**SUNDRY NOTICES AND REPORTS ON WELLS**  
*Do not use this form for proposals to drill or to re-enter an abandoned well. Use form 3160-3 (APD) for such proposals.*

1. Type of Well <input checked="" type="checkbox"/> Oil Well <input type="checkbox"/> Gas Well <input type="checkbox"/> Other		5. Lease Serial No. NMNM114947
2. Name of Operator MACK ENERGY CORPORATION		6. If Indian, Allottee or Tribe Name
Contact: JERRY W SHERRELL E-Mail: jerrys@mec.com		7. If Unit or CA/Agreement, Name and/or No.
3a. Address PO BOX 960 ARTESIA, NM 88211-0960	3b. Phone No. (include area code) Ph: 575-748-1288 Fx: 575-746-9539	8. Well Name and No. KNIGHT FEDERAL 1
4. Location of Well (Footage, Sec., T., R., M., or Survey Description) Sec 3 T23S R23E Mer NMP SWSW 330FSL 660FWL		9. API Well No. 30-015-40305
		10. Field and Pool, or Exploratory INDIAN BASIN; YESO, SOUTH
		11. County or Parish, and State EDDY COUNTY, NM

Mack Energy Corporation  
Knight Federal #1 30-015-40305

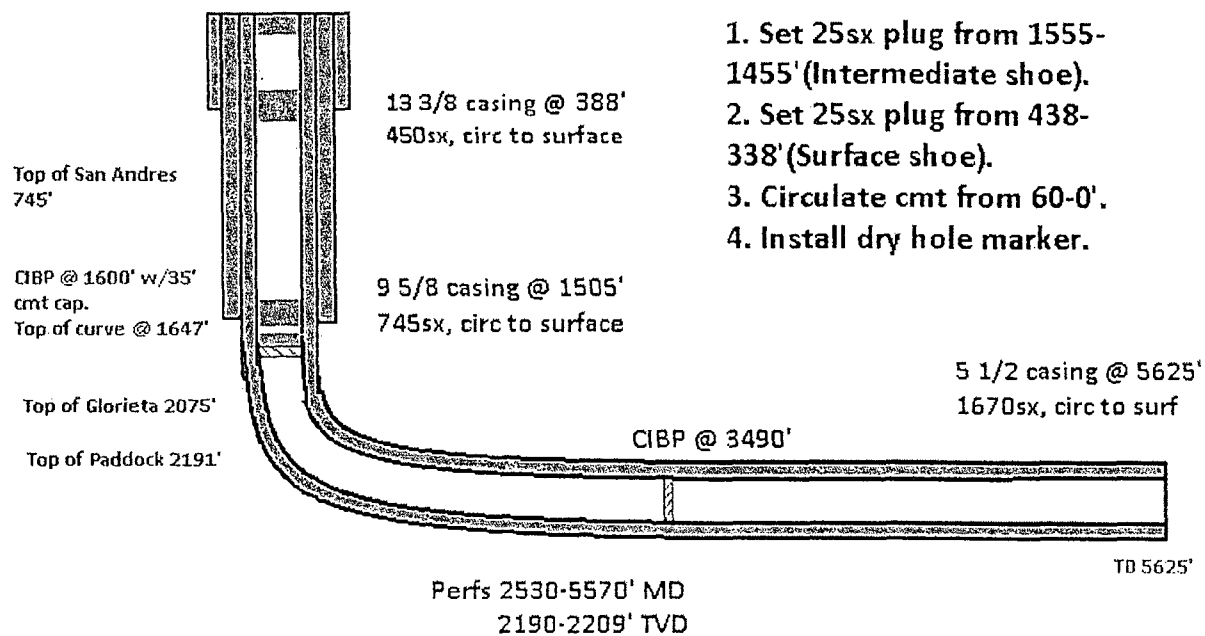
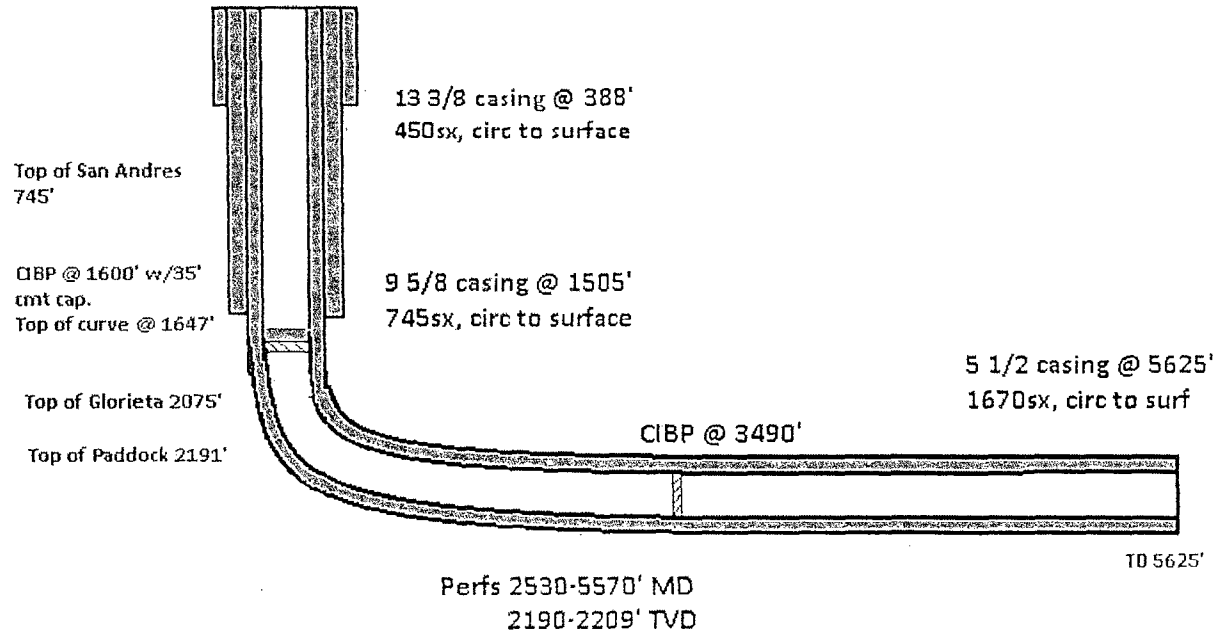
*ADD 25 SX TO COVER T/Glorieta)*  
*woc T23*  
*woc T23*

1. Set 25sx plug from 1555-1455' (covering 9 5/8" shoe).
2. Set 25sx plug from 438-338' (covering 13 3/8" shoe).
3. Circulate cement from 60' to surface.
4. Install dry hole marker.

1. Set 25sx plug from 1555-1455' (Intermediate shoe).
2. Set 25sx plug from 438-338' (Surface shoe).
3. Circulate cmt from 60-0'.
4. Install dry hole marker.
